Technical Service Bulletin: TSB160042

Excessive Gear Train Noise/Whine

Figure 1, Identification Marks on the Rear Face of Suspect Crankshaft Gear

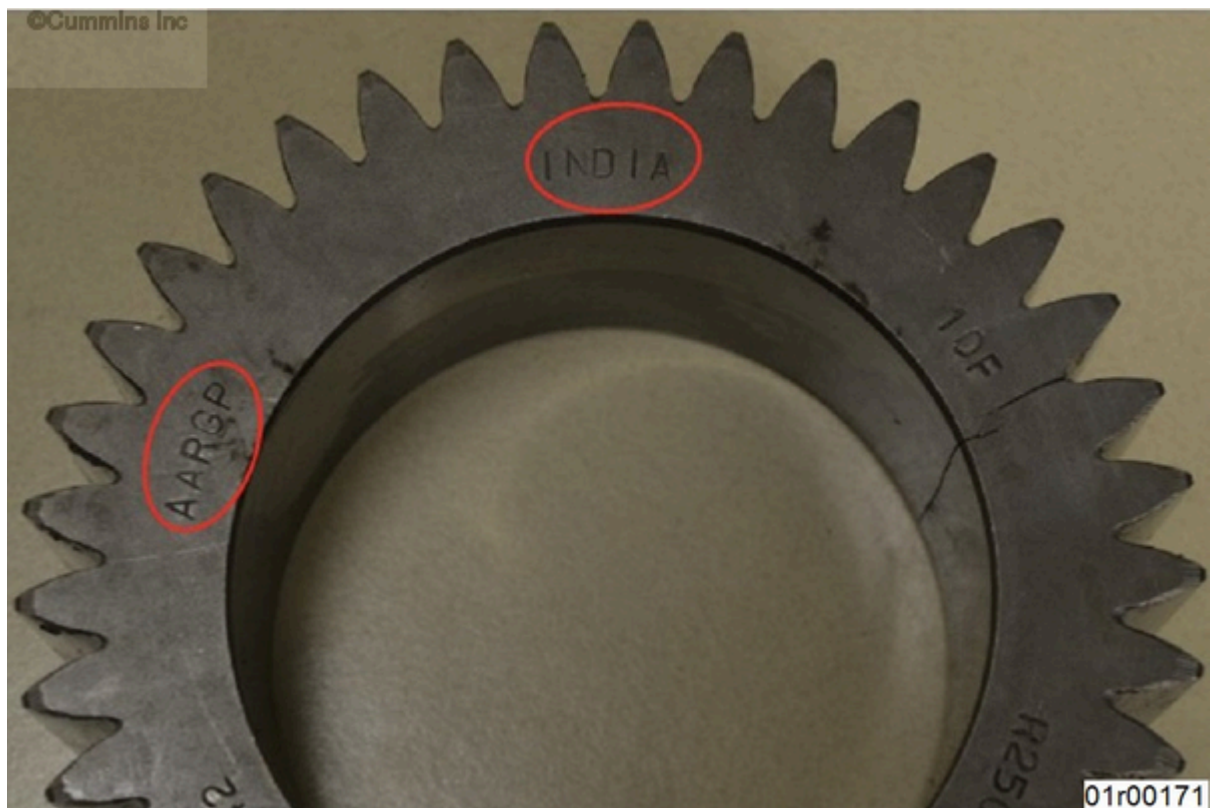
- Crankshaft gear teeth that are out of specification can **not** be visually detected.
- Engines with suspect crankshaft gears were built between May 2015 and January 2016.
- Confirm the crankshaft gear is suspect by looking for the supplier code "AARGP" and "INDIA" stamped on the rear face of the crankshaft gear. See Figure 1 below.
- In some cases, a small mirror may be needed to view the rear face of the crankshaft gear.
- The following audio link below provides an example of an engine with a crankshaft gear with a tooth profile that is out of specification.

- Replace the crankshaft gear. See the corresponding Service Manual. Reference Procedure 001-018 in Section 1.
- Confirm that the gear train noise is no longer present prior to performing other published troubleshooting.
